DATE ~~R~~ Mar.12/03**V2500-D5 NACELLE SERVICE BULLETIN**

This document transmits Revision 1 to Service Bulletin NV2500-78-0170 and
 Revision 1 to the Supplement

Reason for change
 To revise kit contents and
 make related changes to
 text and illustration.

NACELLE - EXHAUST - TRANSLATING SLEEVE AFT LATCH, HEAT SHIELD MODIFICATION/LATCH
ACCESS DOOR HINGE MODIFICATION, THRUST REVERSER

Translating Sleeve Double Latch Closing Force and Gap Adjustment
Figure 4 (Sheet 1)

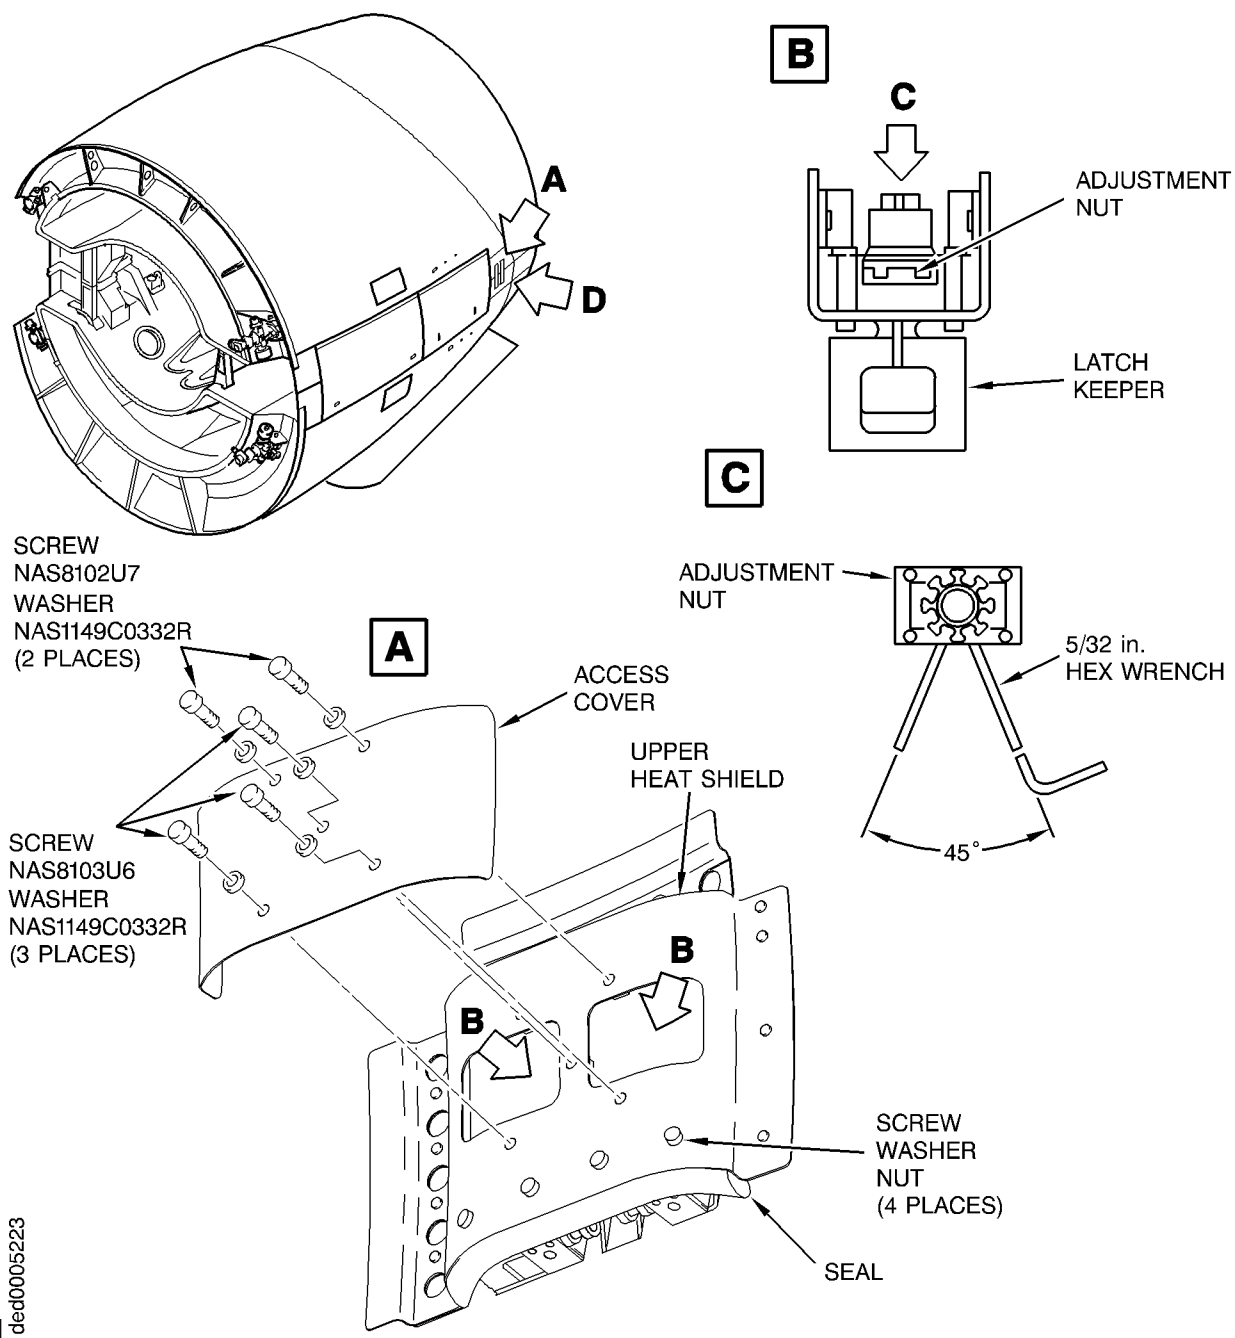
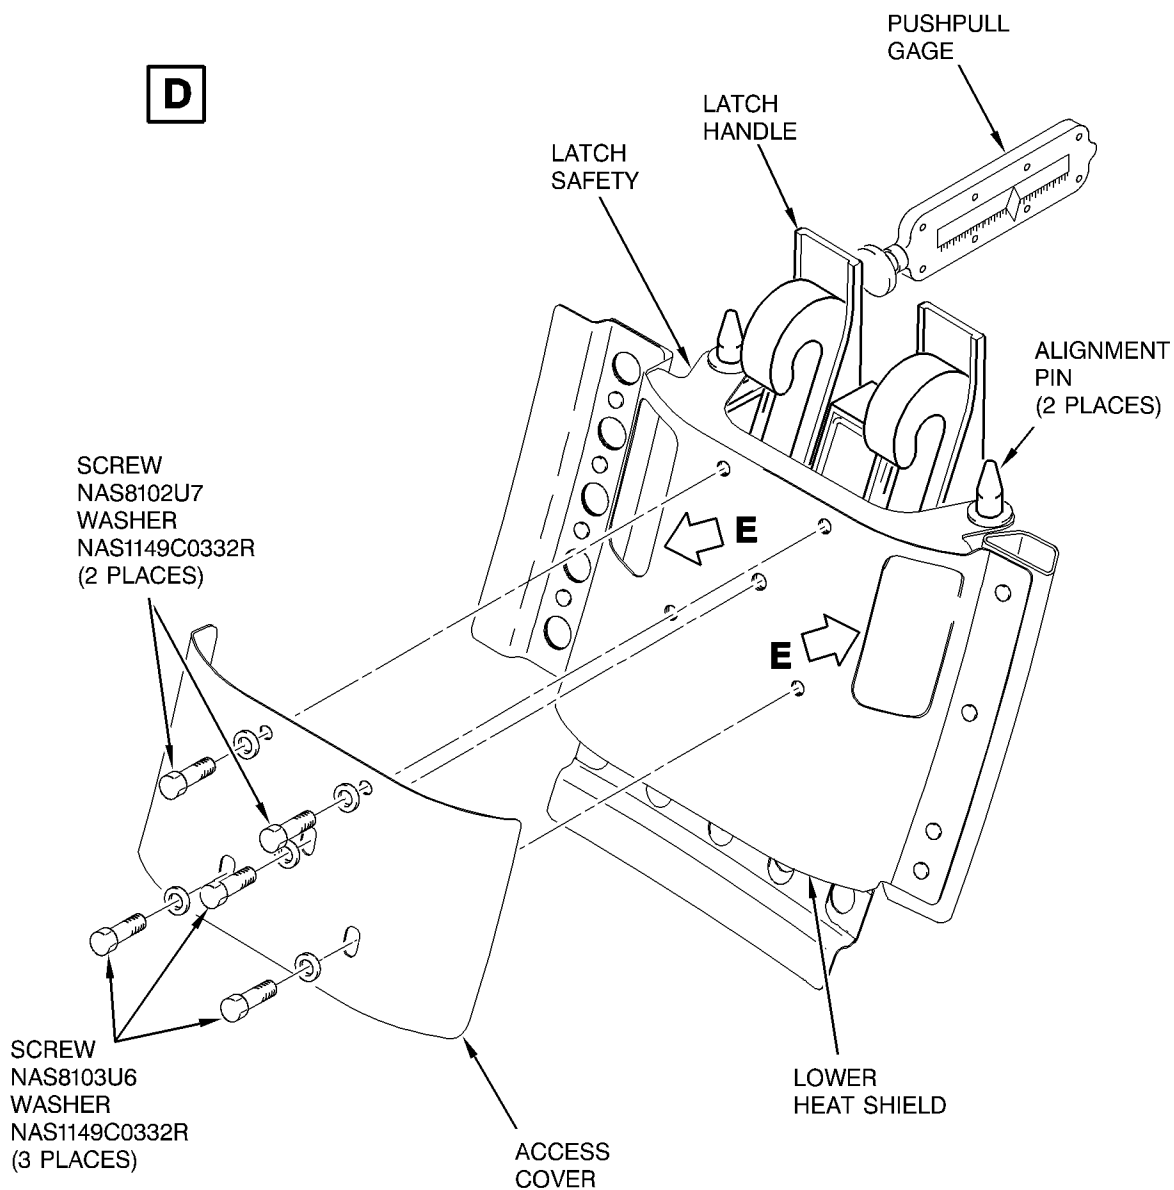
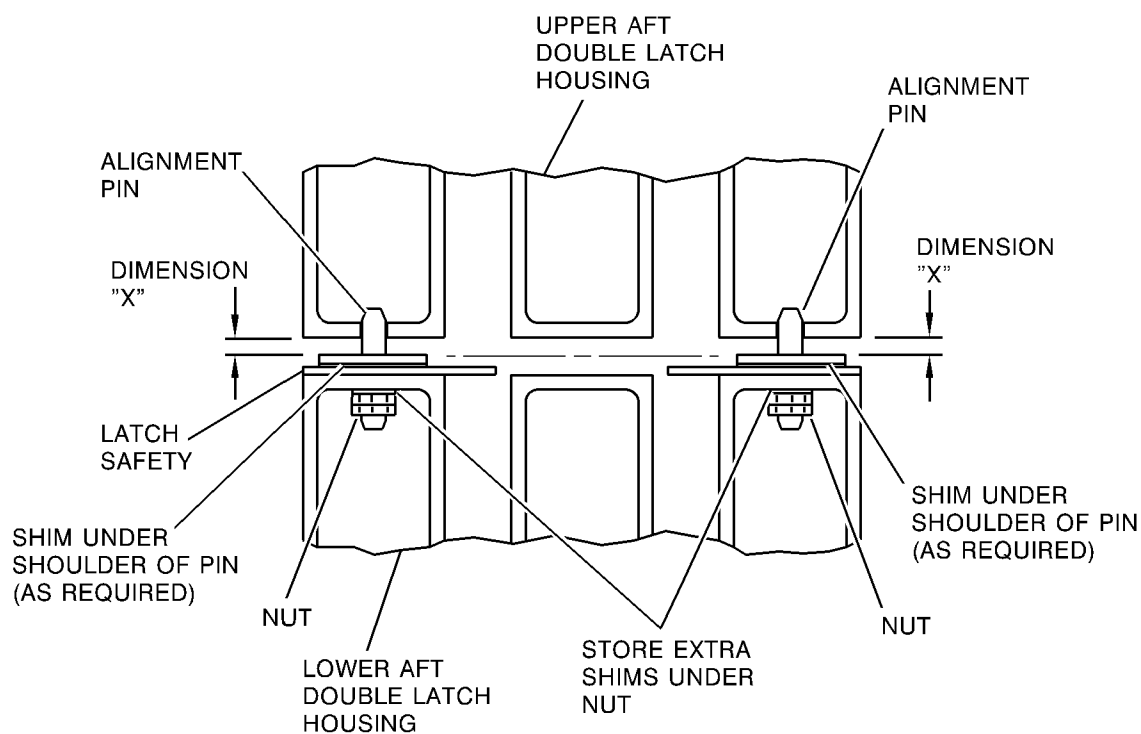
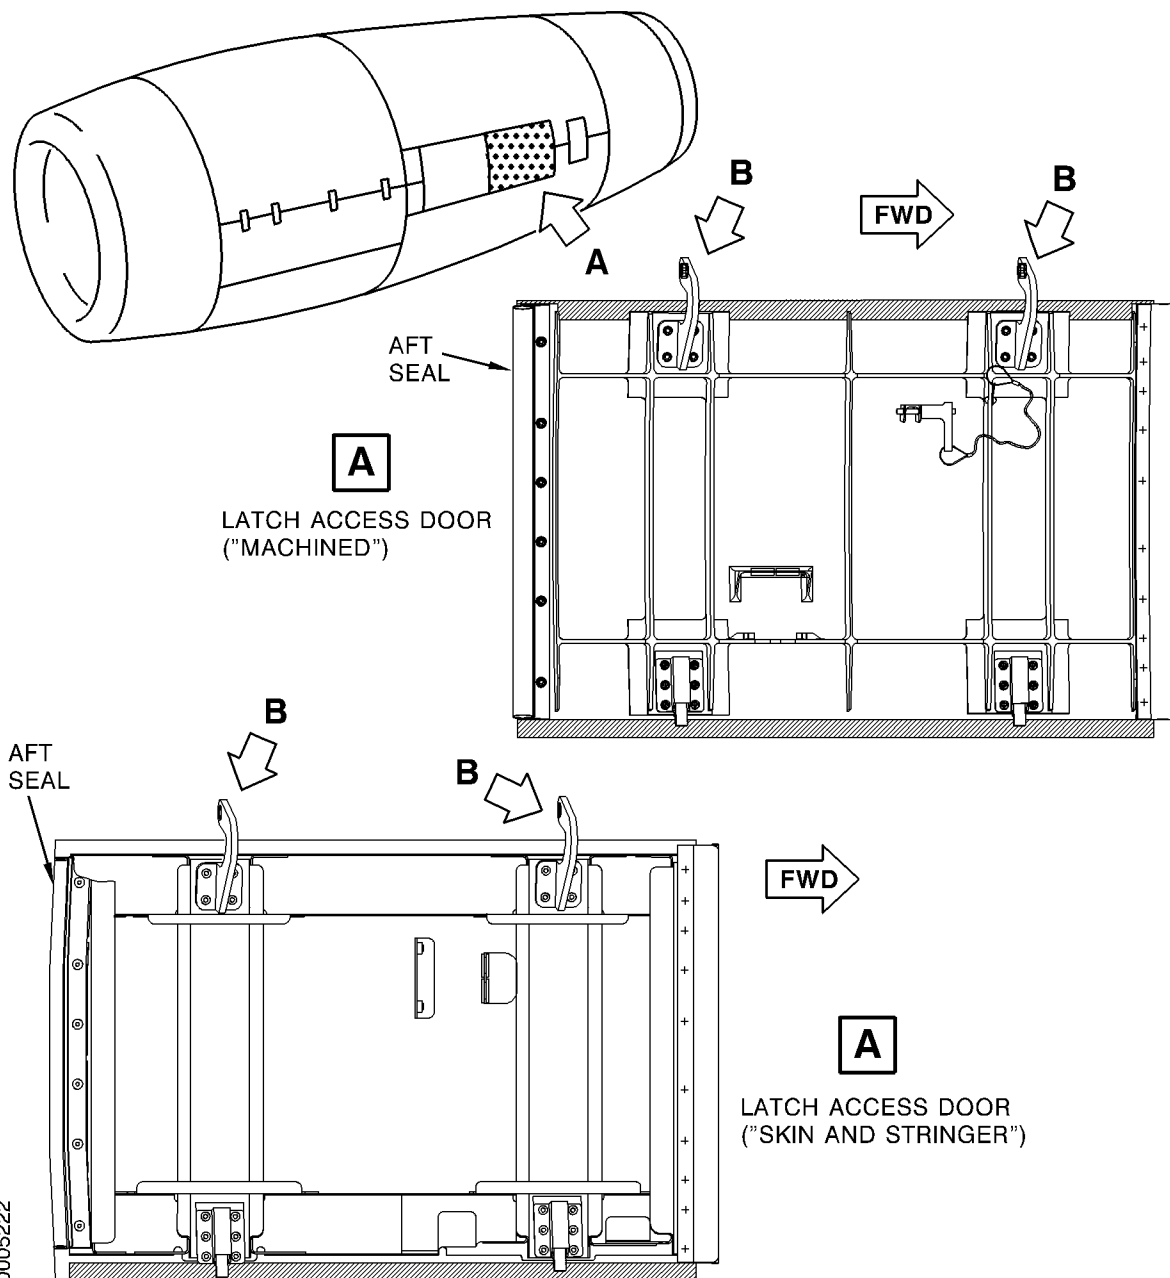
D. Adjust the Translating Sleeve Latch Closing Force. Refer to Figure 4.

- (1) Remove the screws, washers, and access cover from the lower translating sleeve latch heat shield.
- (2) Make sure there are no shims installed with the aft latch locating pins.
- (3) Close the thrust reverser. Refer to the MD90 Aircraft Maintenance Manual, Chapter 78-32-00, Page Block 201.
- (4) Make sure the translating sleeve aft double latch closing force is 45 to 55 lbs. (200 to 240 N). Use the push pull gage. Adjust the keepers or latches as necessary to get the correct closing force.

E. Measure and adjust the space between the translating sleeve aft double latch housings. Refer to Figure 4.

- (1) Find the amount of shim needed at the translating sleeve aft double latch locating pins.
 - (a) With the translating sleeve double latch properly adjusted and closed, measure and make a record of the spaces (dimension 'X') between the lower surface of the upper translating sleeve latch housing and the shoulders of the locating pins on the lower translating sleeve latch housing.

- (b) Add the two measurements from step E.(1)(a) together and divide the total by two to determine the average space dimension. Then add 0.070 inch (1,78 mm.) to the average. This total is the thickness of shim you need to install under the shoulders of each of the locating pins.

- (2) Install the shims between the latch safety and the locating pins.
 - (a) Remove the nuts, washers and locating pins.
 - (b) Install the 290-0547 shims, 290-0158-503 locating pins, AN960C616L washers, and NAS1805-6 nuts. Install any extra shims under the nuts.

Latch Access Door Hinge Doubler Installation
Figure 5 (Sheet 1)

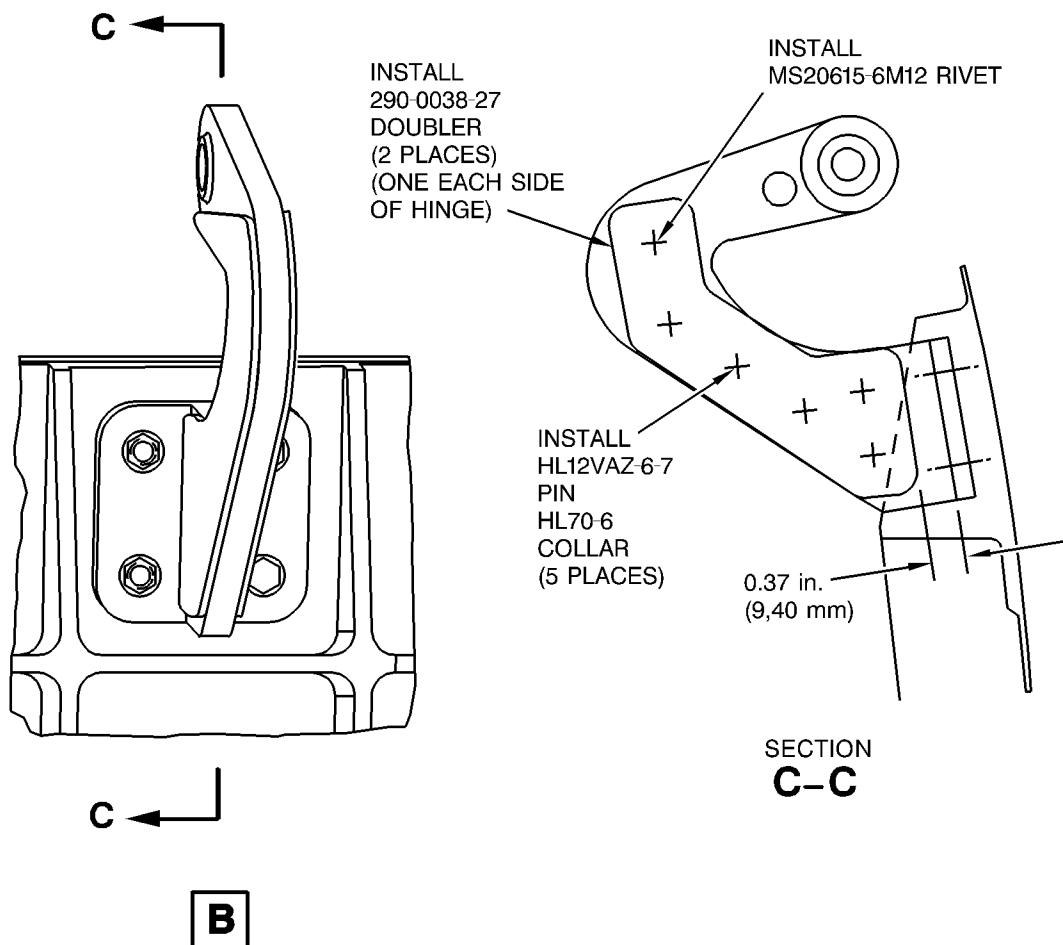
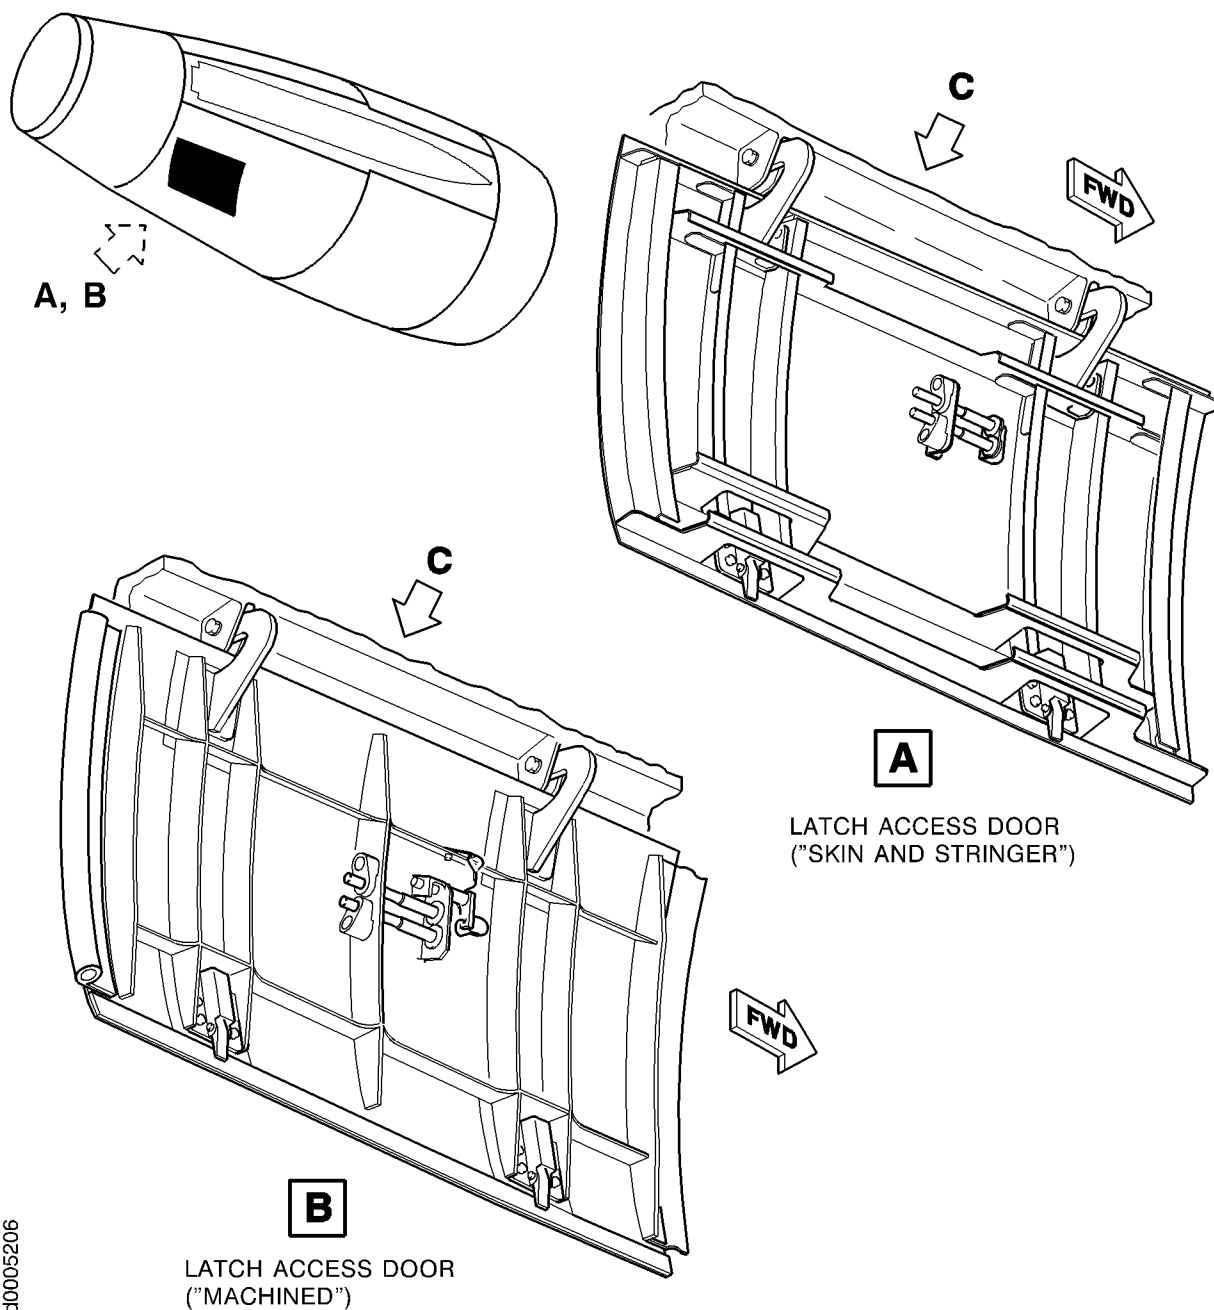
- F. Install the 290-0928-505 (-506) access panels on the upper and lower translating sleeve latch heat shields with the NAS1149C0332R washers, NAS8102U7 screws, and NAS8103U6 screws.
- G. Adjust the 290-0003 seal on the upper translating sleeve heat shield until it is compressed 10% to 30% against the latch safety on the lower translating sleeve. Tighten the nuts.
- H. Install the doublers on the latch access door hinges. Refer to Figure 5.

- (1) Remove the thrust reverser latch access door. Refer to the MD90 Aircraft Maintenance Manual, Chapter 78-32-09, Page Block 401.
- R (2) Put the 290-0038-27 doublers into position on the latch access door hinges and drill the holes for the 3/16 diameter HL12VAZ-6-7 pins and MS20615-6M12 rivets.
- (3) Clean the hinges and the doublers with a lint free cloth (CoMat 02-099) made moist with solvent (CoMat 01-438). Wipe the surfaces dry before the solvent becomes dry.

- (4) Mix the catalyst (CoMat 07-139), epoxy primer (CoMat 07-140), and thinner (CoMat 07-144). Refer to the manufacturer's instructions.
- (5) Apply the primer mix to the mating surface of the doublers.
- (6) Allow the primer mix to dry. Refer to the manufacturer's instructions.
- R (7) Install two 290-0038-27 doublers on each hinge with the HL12VAZ-6-7 pins,
R HL70-6 collars and MS20615-6M12 rivet. Wet install the fasteners with primer mix.

- (a) If there is too much looseness or 'free-play', check for proper installation of the attach hardware and replace any worn, damaged, or missing bushings. Refer to Figure 6.
- (11) Adjust the latch access door aft seal. Refer to Figure 5.
- (a) Loosen the nuts and move the 290-0038-23 aft seal until it is compressed 10% to 30% against the translating sleeve when the latch access door is closed. Tighten the nuts.
